INNER WEST COUNCIL

DEVELOPMENT ASSESSMENT REPORT

Application No.	DA201900238
Address	122 Victoria Street Dulwich Hill
Proposal	To restore and reconstruct the heritage listed dwelling house following the unauthorised partial demolition of the structures
Date of Lodgement	12 July 2019
Applicant	Home Impact
Owner	122 Victoria St Pty Ltd
Number of Submissions	Nil
Value of works	\$300,000
Reason for determination at Planning Panel	Heritage Item
Main Issues	Restoration/reconstruction to heritage item
Recommendation	Approved with Conditions
Attachment A	Recommended conditions of consent
Attachment B	Plans of proposed development
Attachment C	Statement of Heritage Significance

Figure 1: Non-compliance with ADG for rear setback the original submission

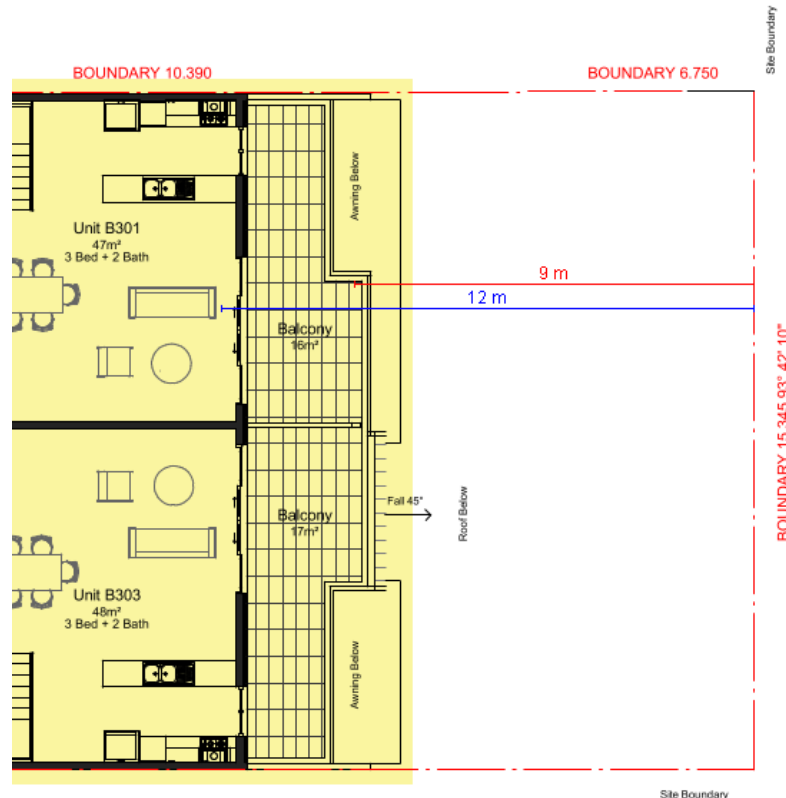
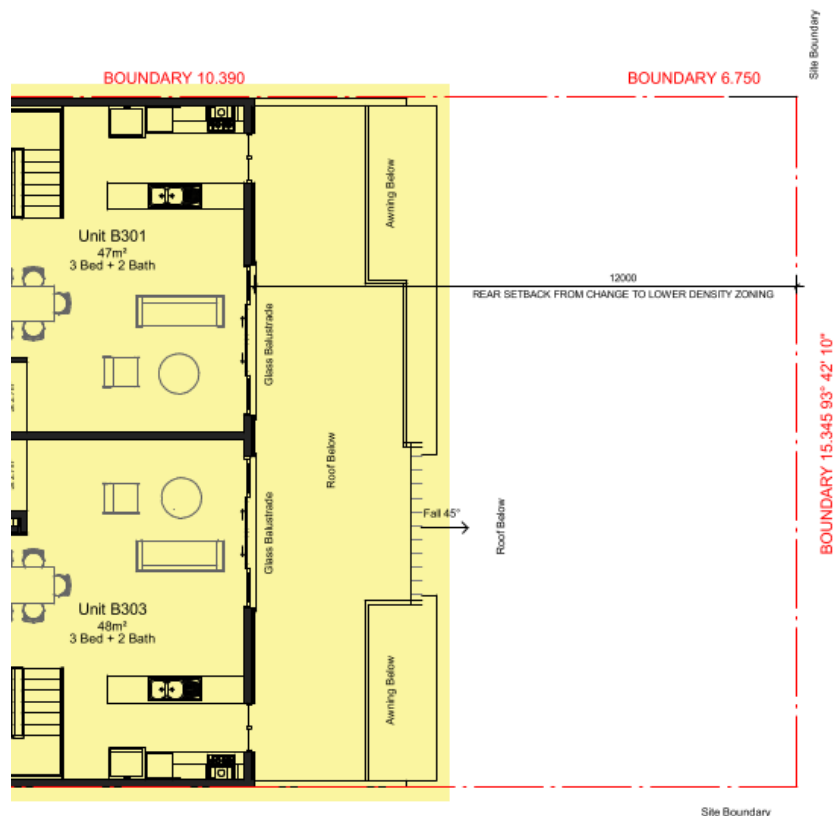
The balconies of the originally proposed fifth floor provided a setback of approximately 8.6m. It is noted that the adjoining property to the rear is zoned R1 General Residential which permits residential flat building and multi dwelling housing but has a low density FSR of 0.6:1 and as a result the requirement is to provide an additional 3m to the above figures. Given that the rear use of the property is that of a dwelling house and a walk up RFB and the adjoining properties fifth storey is not setback the required distance by the ADG inclusive of the additional 3m. After being advised of the need to condition the proposal to compliance with the ADG, the applicant elected to submit amended plans to make the proposal comply with the ADG requirements.

Figure 2: Amended submission that is compliant with the ADG for rear setback

Figure 3: Non-compliance with the ADG requirements for separation from the original submission

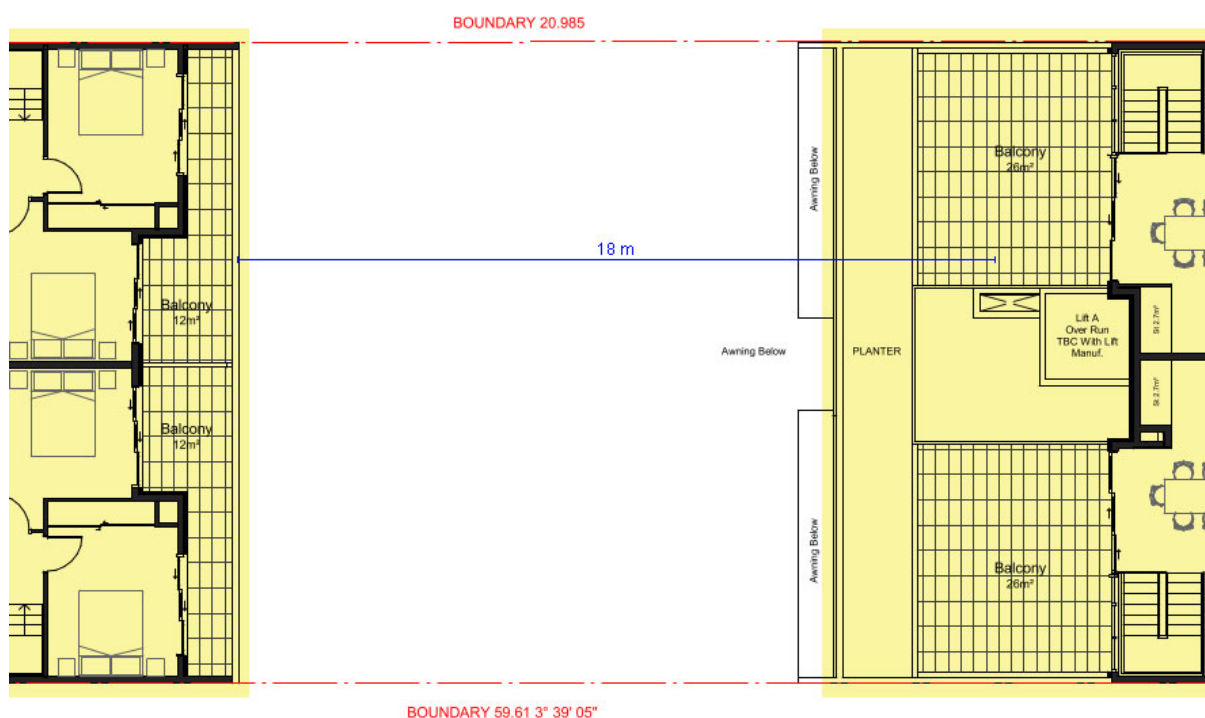
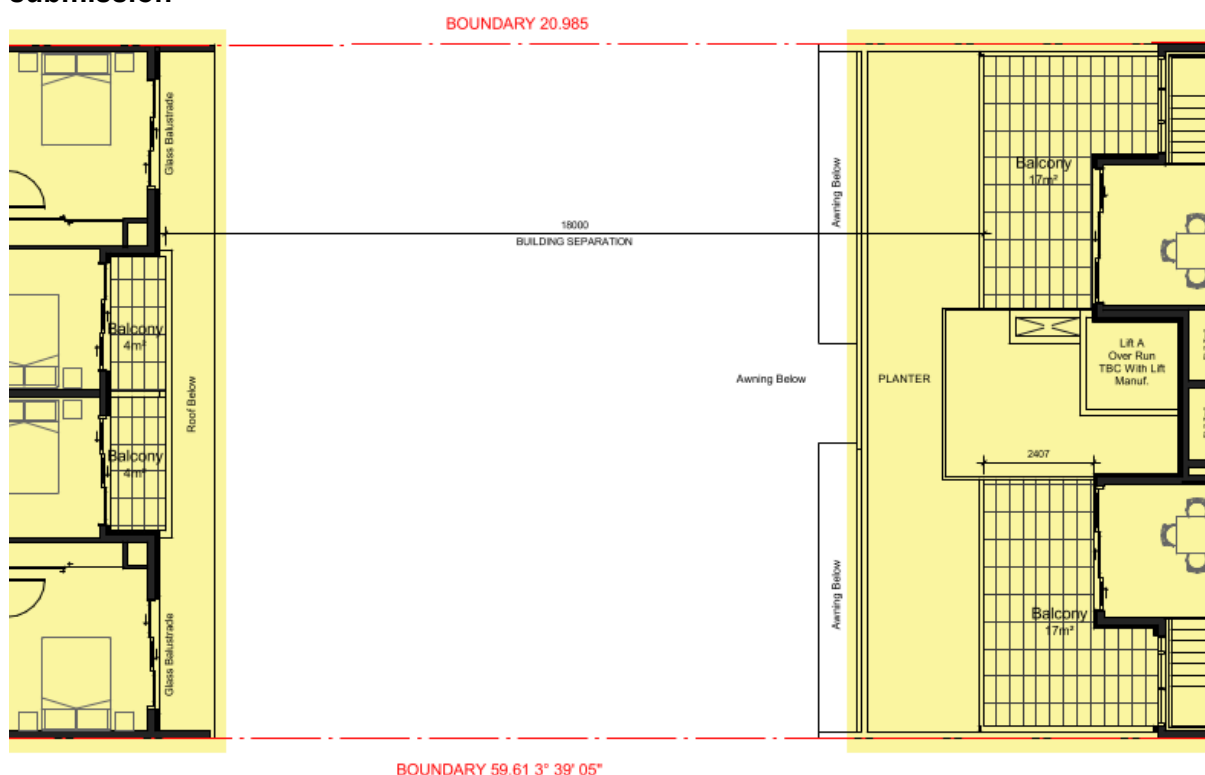
The originally proposed fifth floor also failed to meet the requirements for separation between balconies. The intent of these controls is to increase the level of separation as the building height increases. In this case the development has largely followed the existing building separation. Noting that the proposal exceeds the FSR and height development standards the controls for separation of building represent an important constraint on the extent of the development and assist in preserving the amenity of the future residents. After being advised of the need to condition the proposal to compliance with the ADG, the applicant elected to submit amended plans to make the proposal comply with the ADG requirements.

Figure 4: Amended submission that is compliant with the ADG for rear setback

Figure 5: Compliance with rear setback control.

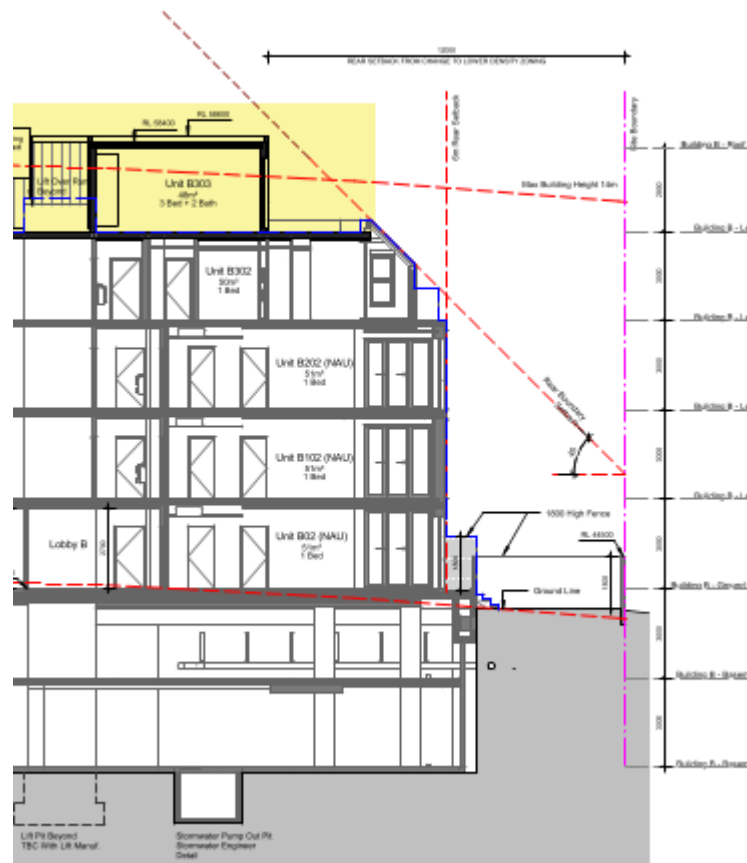
The proposed modification does not result in a non-compliance with the front side and rear setbacks and massing controls.

Figure 6: Overshadowing impacts at 3PM to adjoining north facing balconies

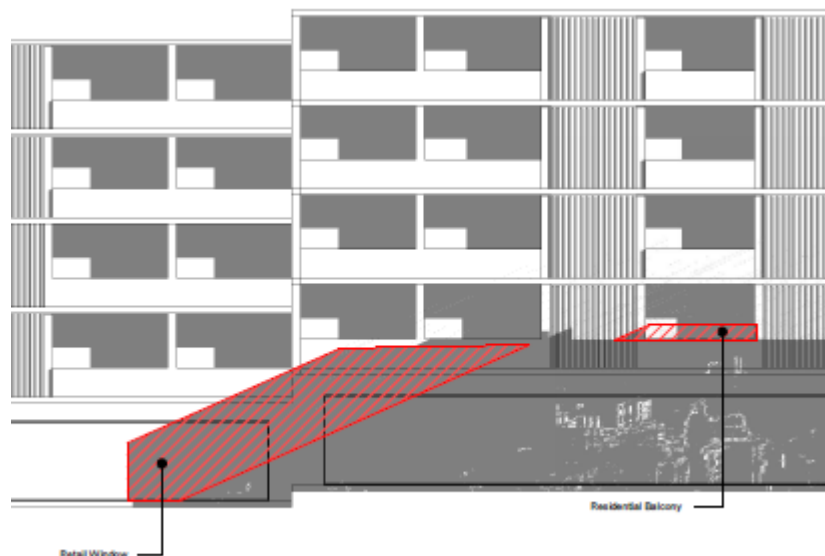
Comment: The level of overshadowing caused by the proposed modification is consistent with the requirements of C2 within Part 2.7.3 of the Marrickville DCP 2011, which are the applicable development controls. The overshadowing is largely to the rear of the retail level with overshadowing only occurring at 3pm for a small section of one balcony, which is well within the parameters of the relevant controls within Marrickville DCP 2011.
